## NGG PROGRAM MANUAL

NGGM-PM-0033

Revision **54**

**Title: New Nuclear Plant Development Quality Assurance Program**  
**Description Topical Report**

Figure II.1-1

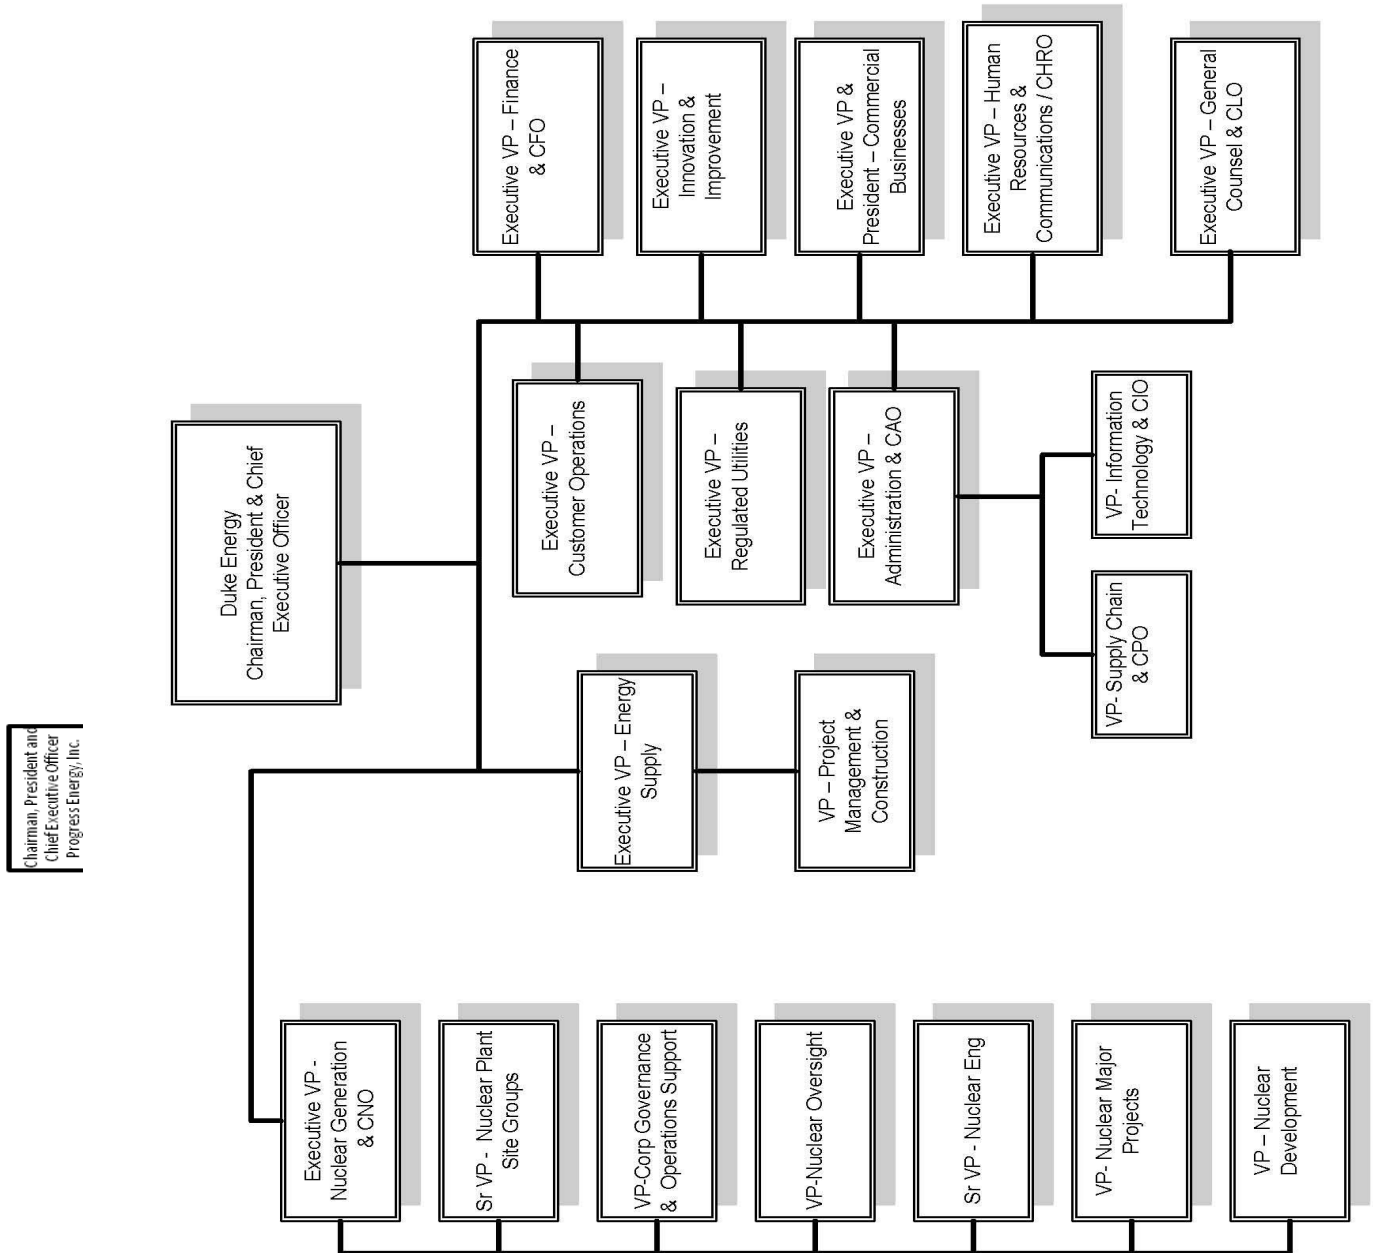
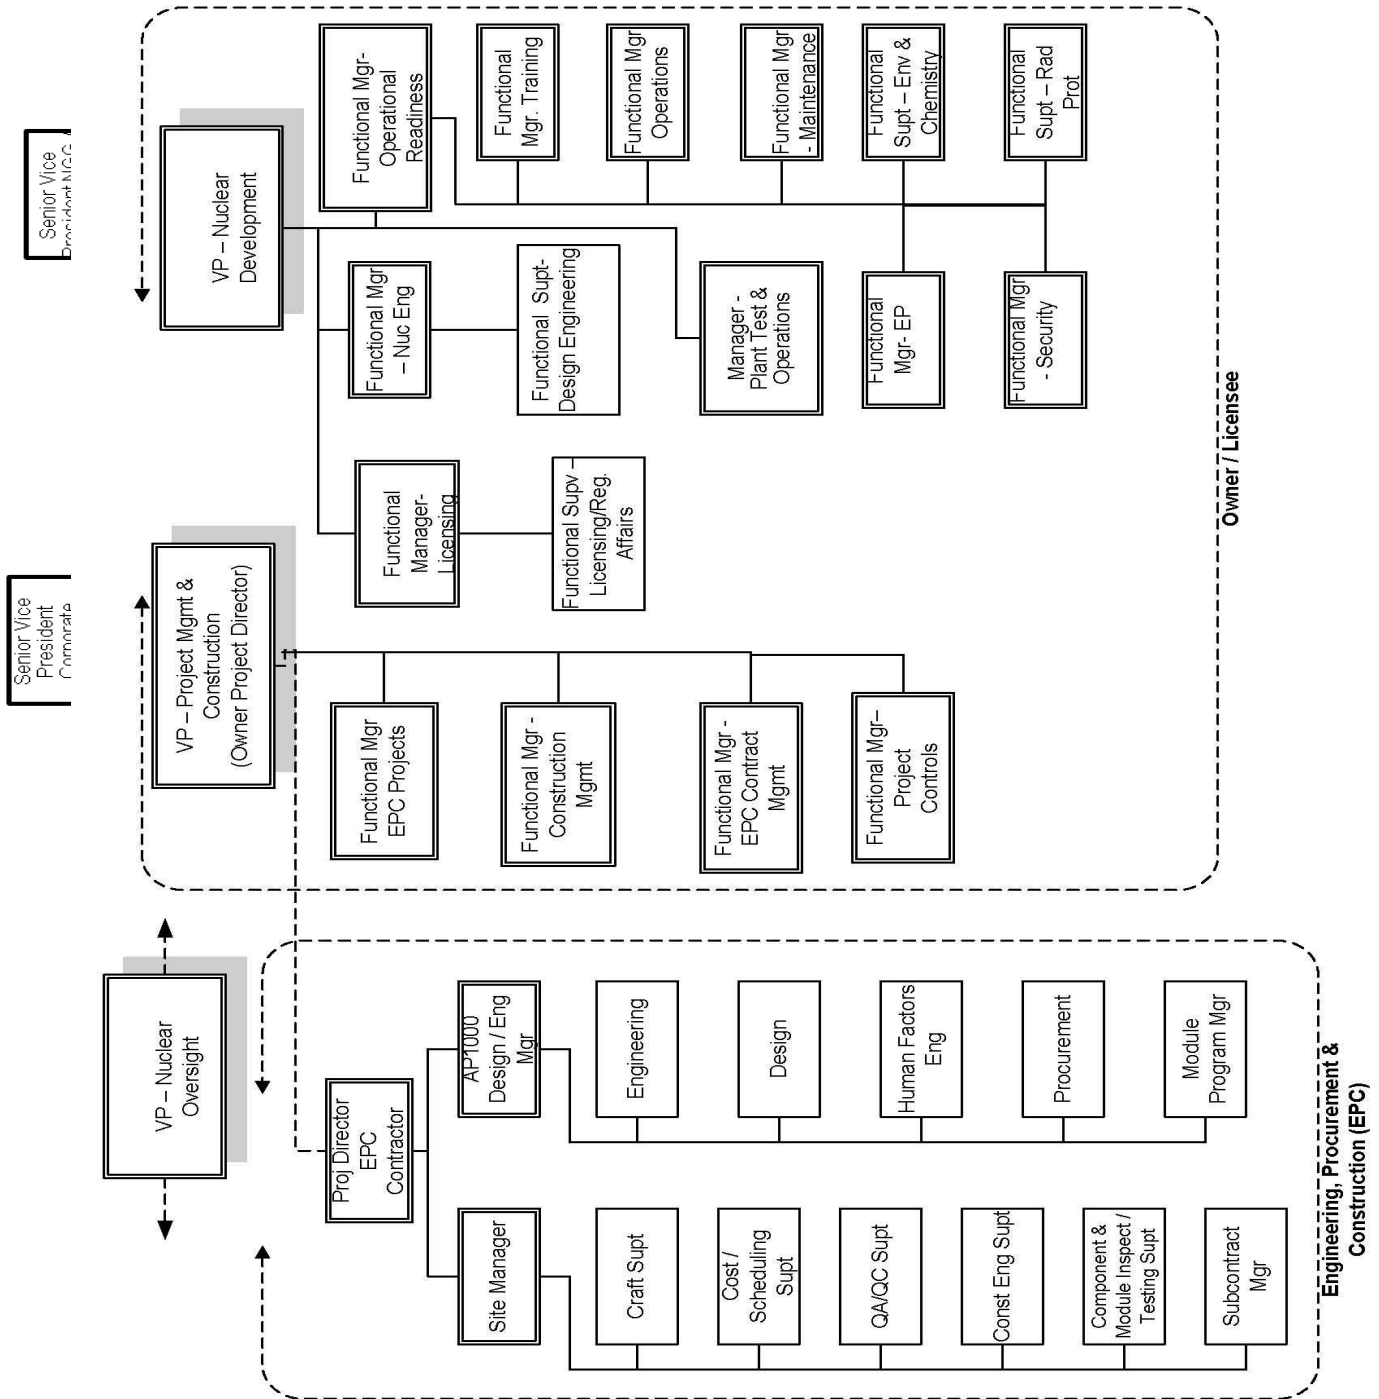
- Part II, Section 1.5 – 1.10 – Changed section numbering to reflect changes in section. No changes in section descriptions.
- Part II, Figures II.1-1, II.1-2, and II.1-3 – Revised figure to reflect new organizational structure and titles.
